**PLANNING COMMISSION MEETING
AGENDA
CITY OF WHITE BEAR LAKE, MINNESOTA**

- A. **Case No. 20-1-P:** A request by **321 Group LLC** for a preliminary plat, per Code Section 1402.020, to subdivide one parcel into 9 single-family residential lots on the property located at 1800 County Road E.

TO: Samantha Crosby, Planning & Zoning Coordinator

The Engineering Department reviewed the Civil Plans and Stormwater Drainage Report dated October 26, and received October 27, 2020, and have the following comments in **red text**. Comments in black text are from review comments dated September 18, 2020.

SHEET
C1.01

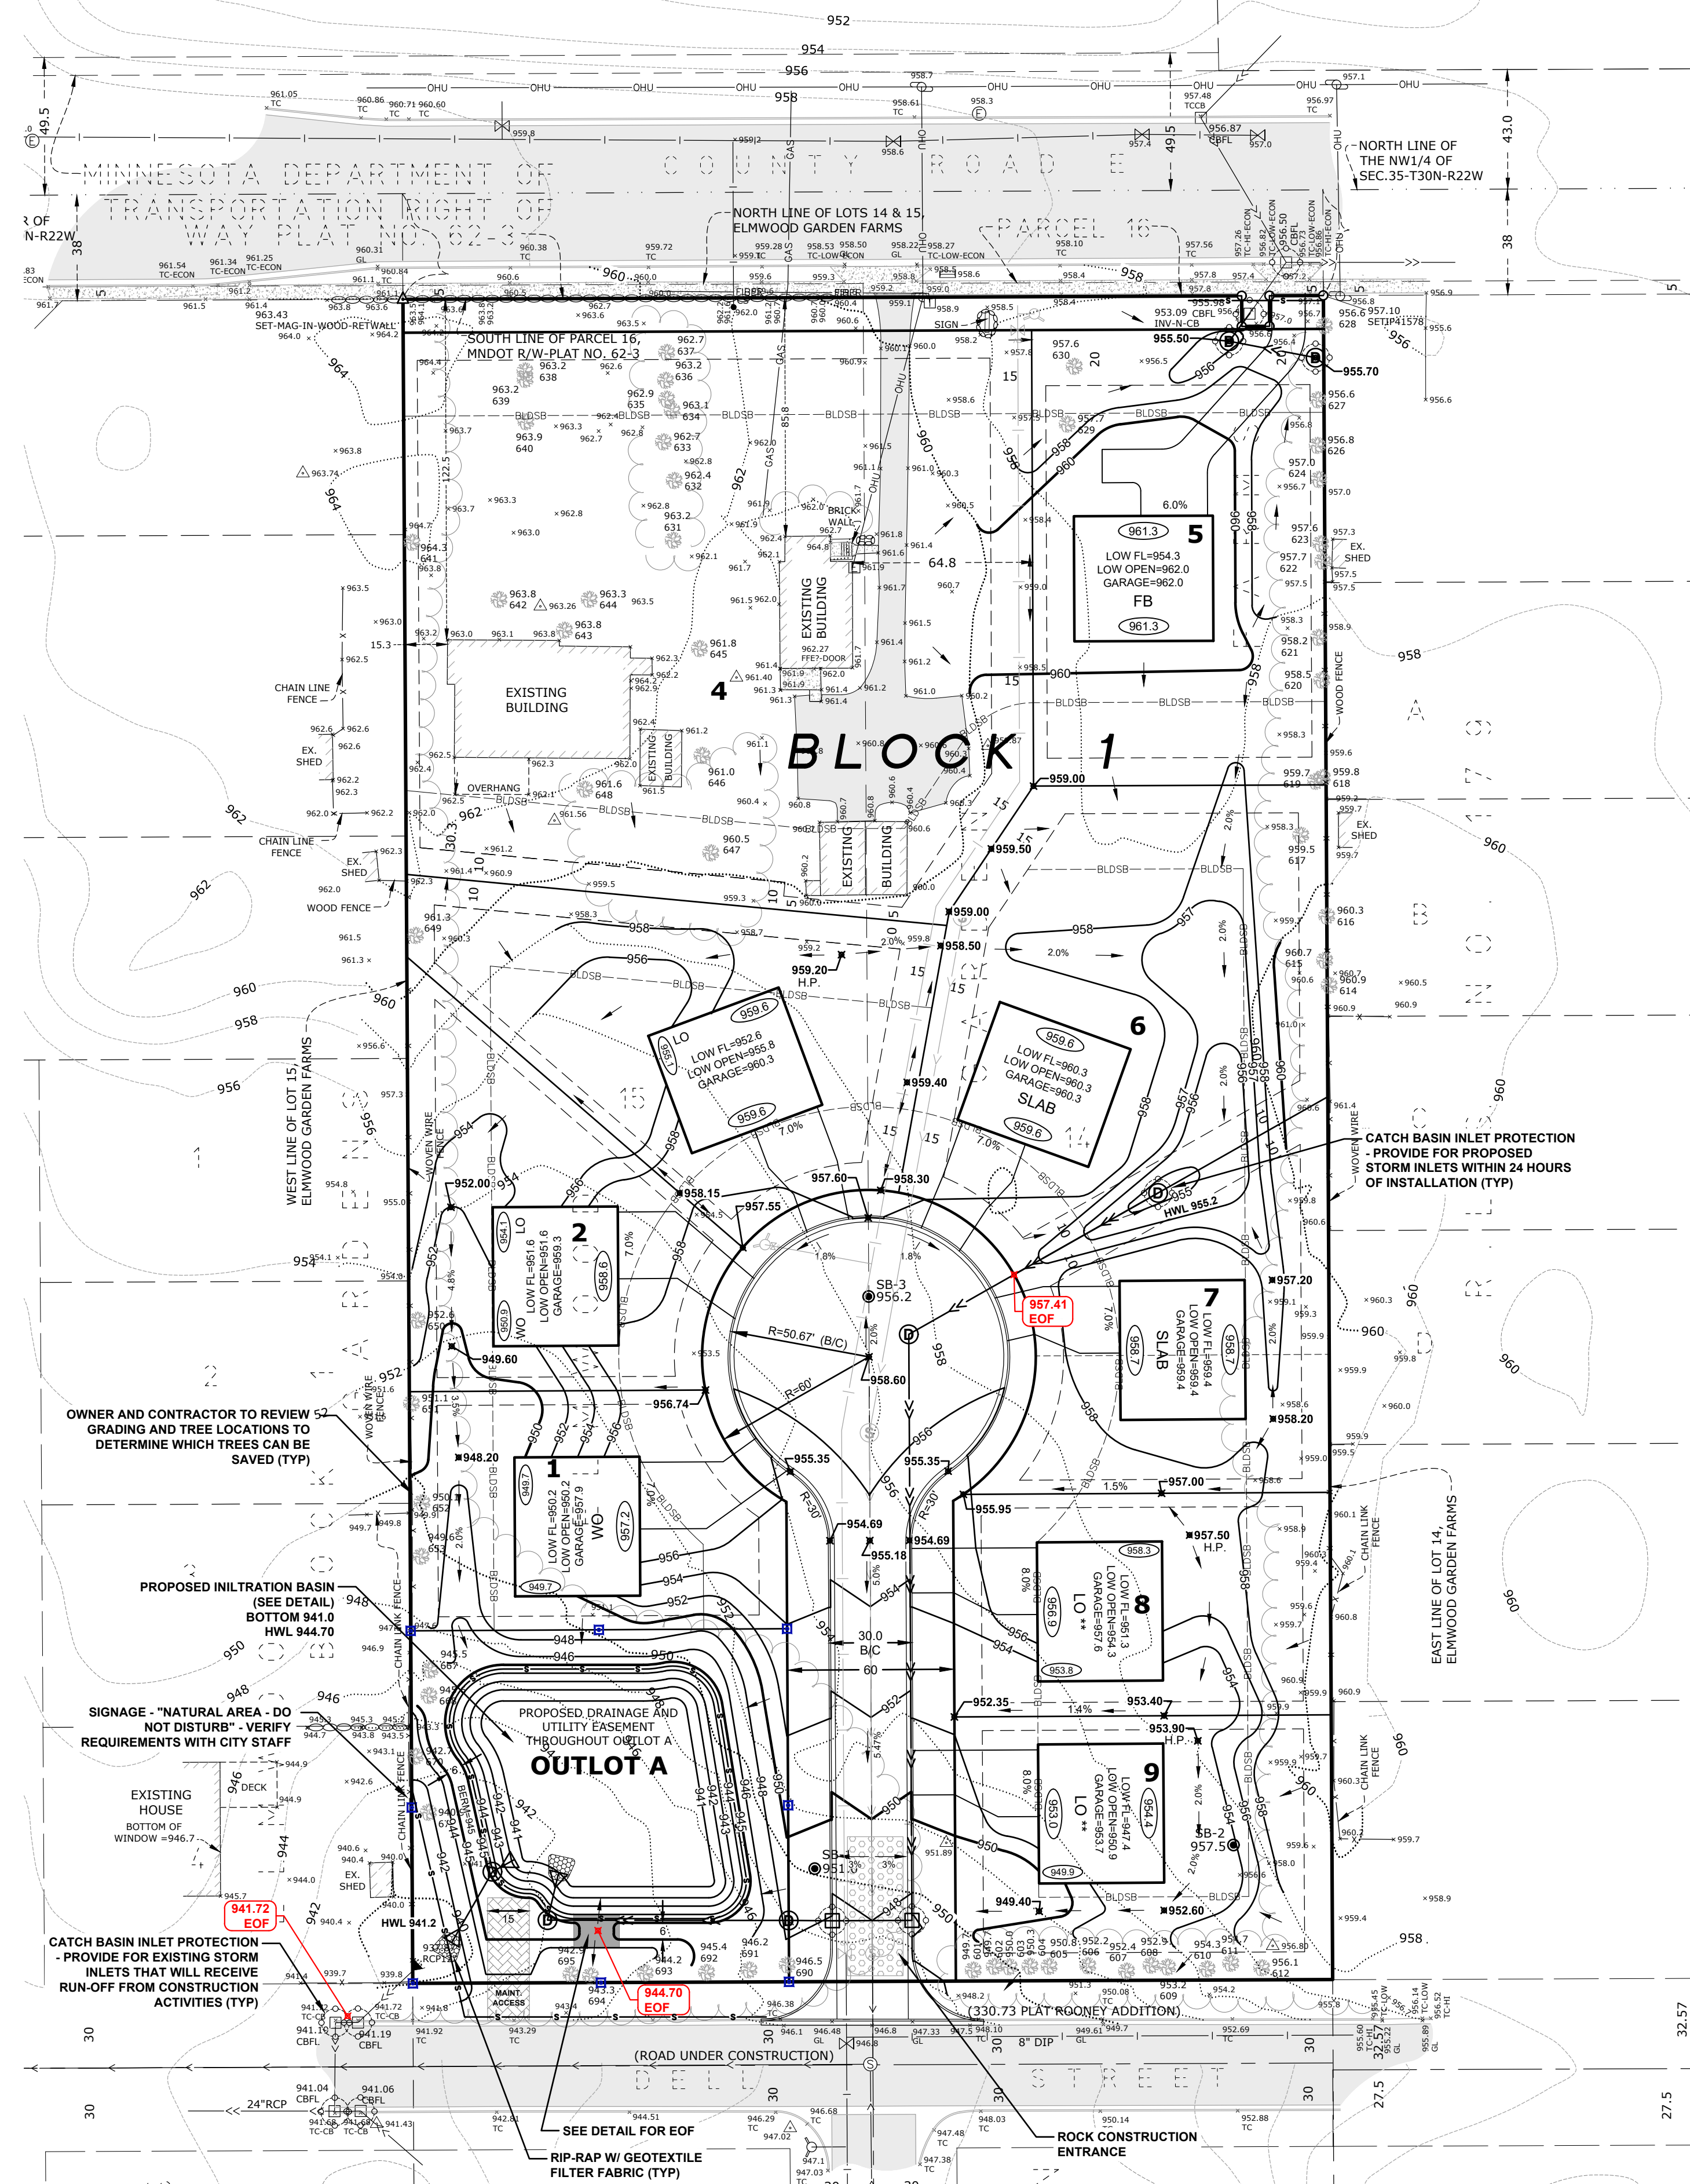
- 3) Dimension street from face of curb to face of curb. 30 feet face to face is acceptable. If driveway slopes are too steep, the street can be a minimum of 28 feet face to face.
11/6/20: This item has not been addressed. (Please either use 30.0 F-F or 31.34' B/C)
11/6/20: Please label the EOF for lot 5.
- 4) Include tree protection fence at the grading limits along the entire east side of the property, west side of the property, and northern area of lot 3.
11/6/20: This item has been addressed on Sheet 1.02. Please show on Sheet 1.01 as well.

- 5) Remove the ‘Sodded EOF’ note and replace with permanent erosion control blanket and native seed.

11/6/20: The EOF will also be planted by the restoration contractor; therefore, please remove the MnDOT seed mix note and add a note that references a native seed mix designed by others.

SHEET
C1.02

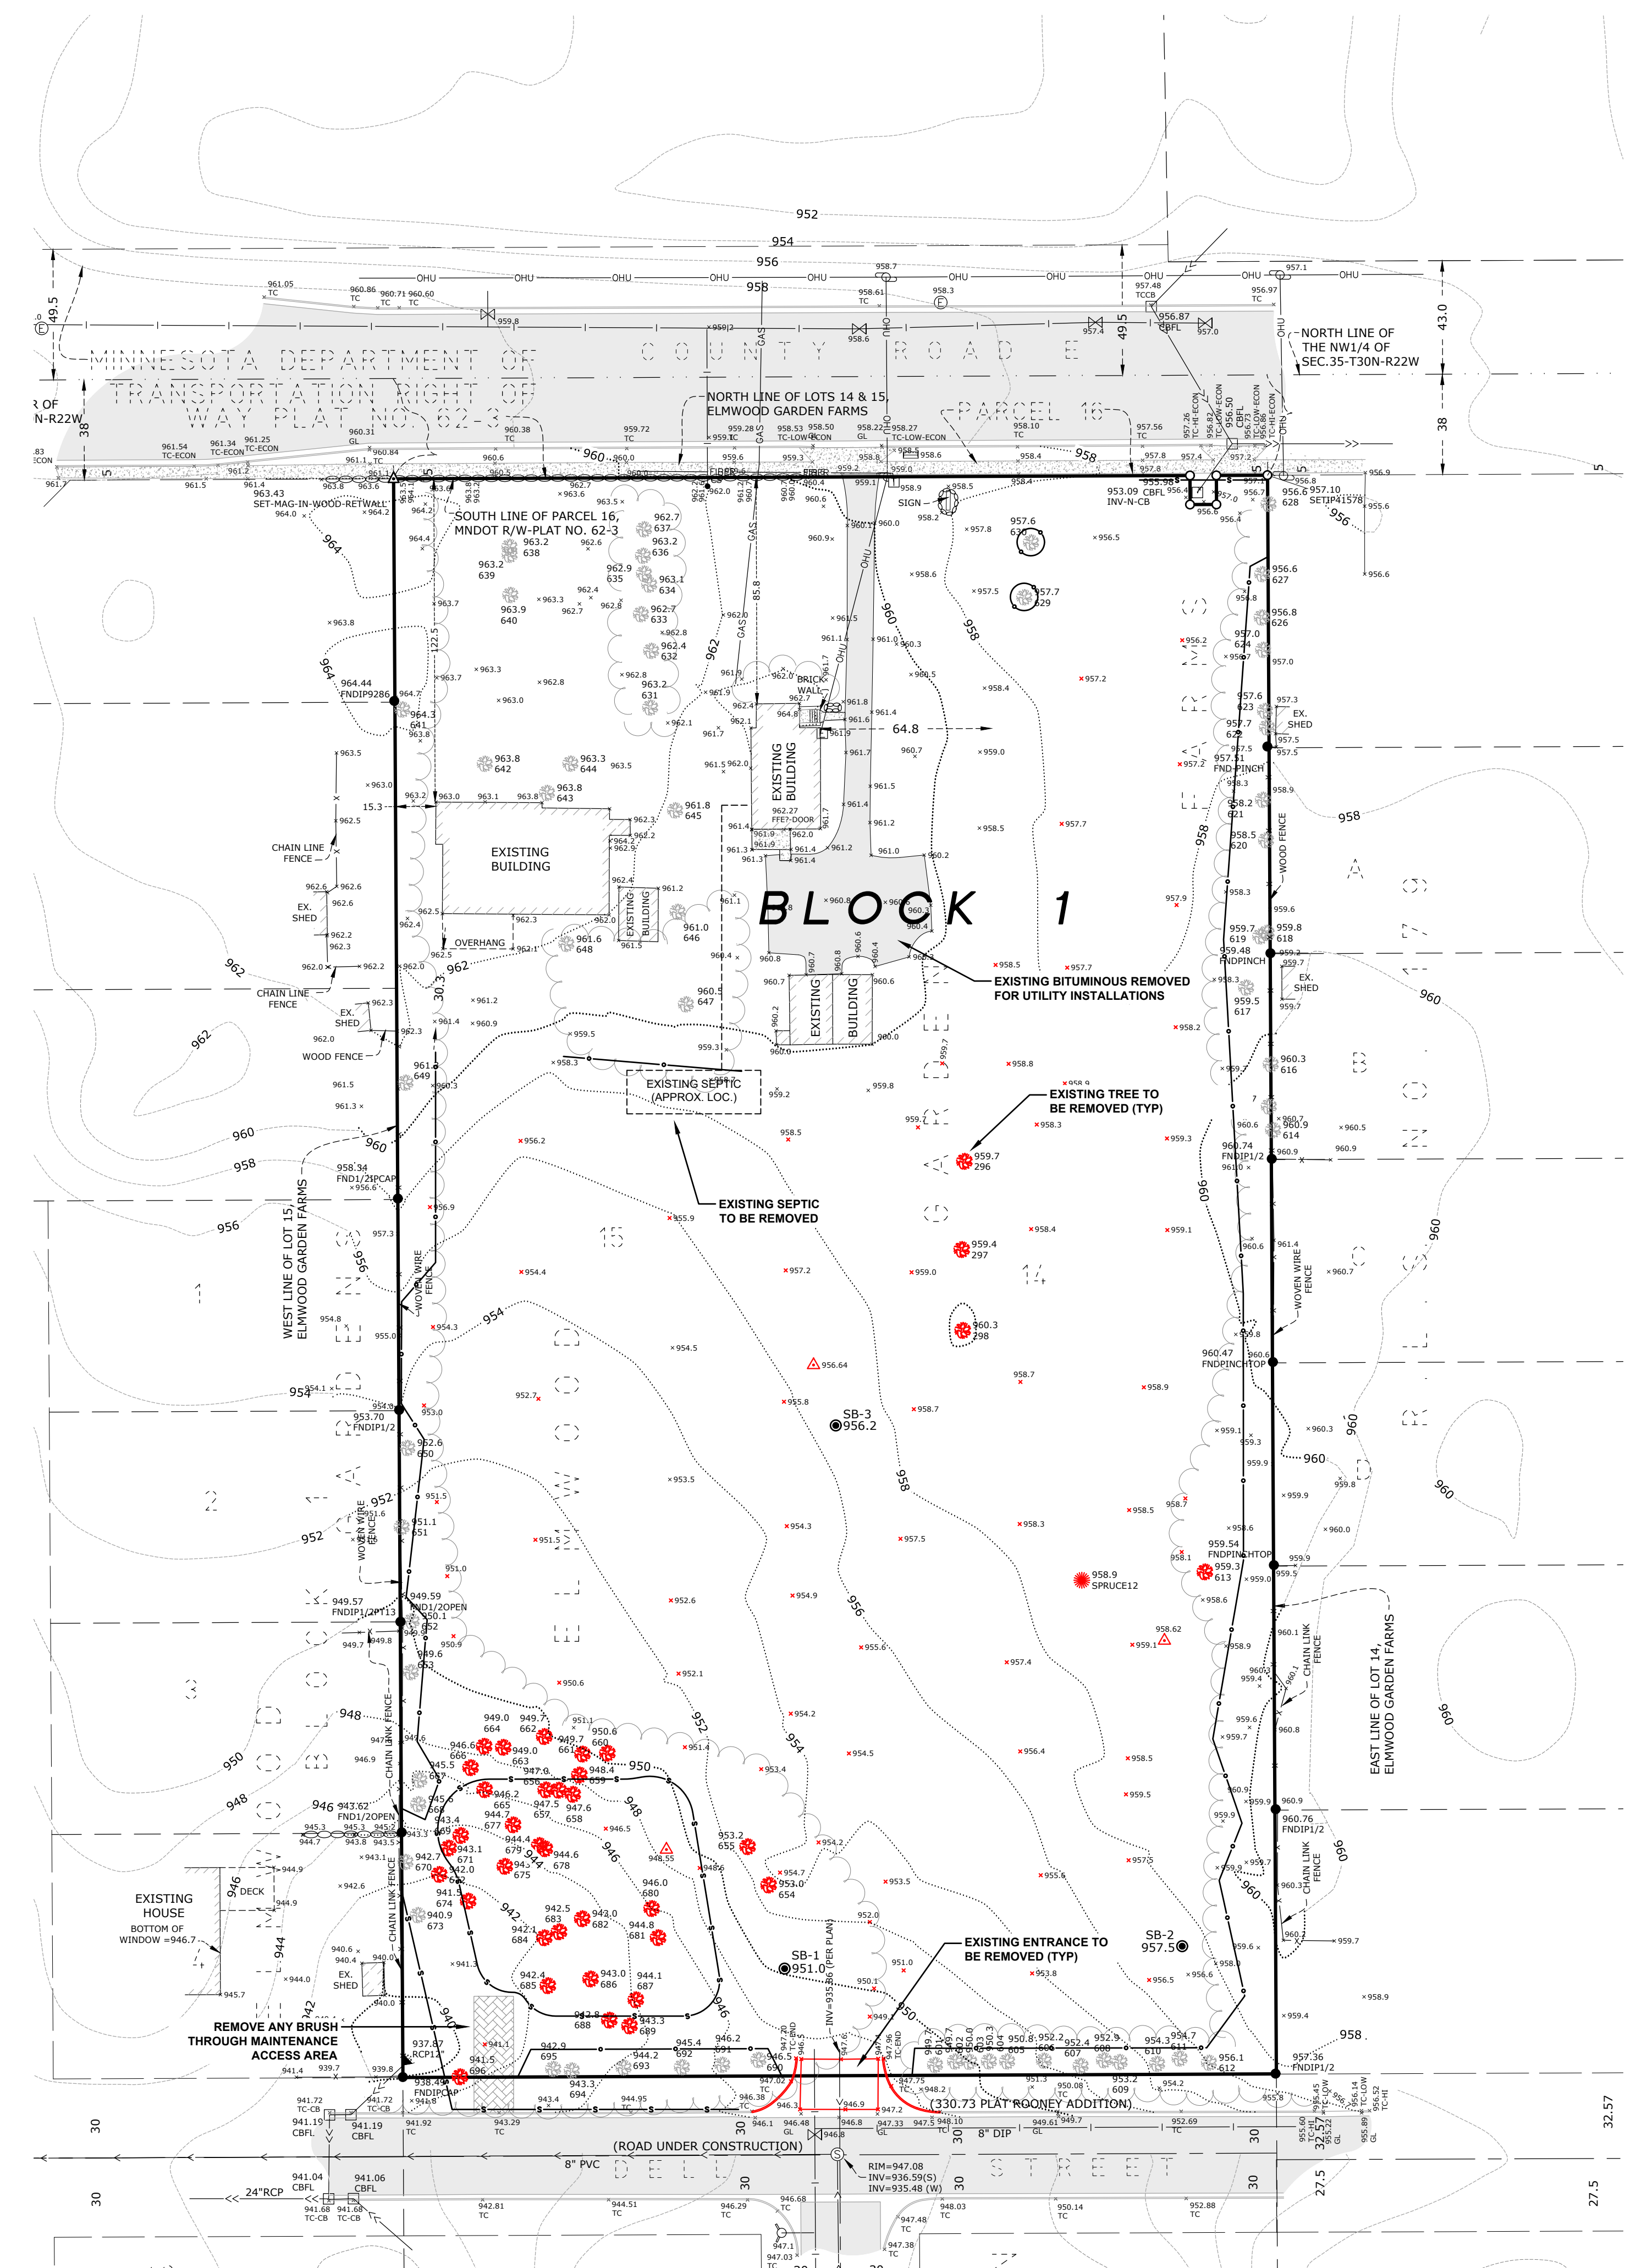
- 6) Add the additional tree protection fence from comment 17 on this plan sheet.

CTAILLONE@WHITEBEARLAKE.ORG, please change to

CTAILLON@WHITEBEARLAKE.ORG, to reflect the correct e-mail.
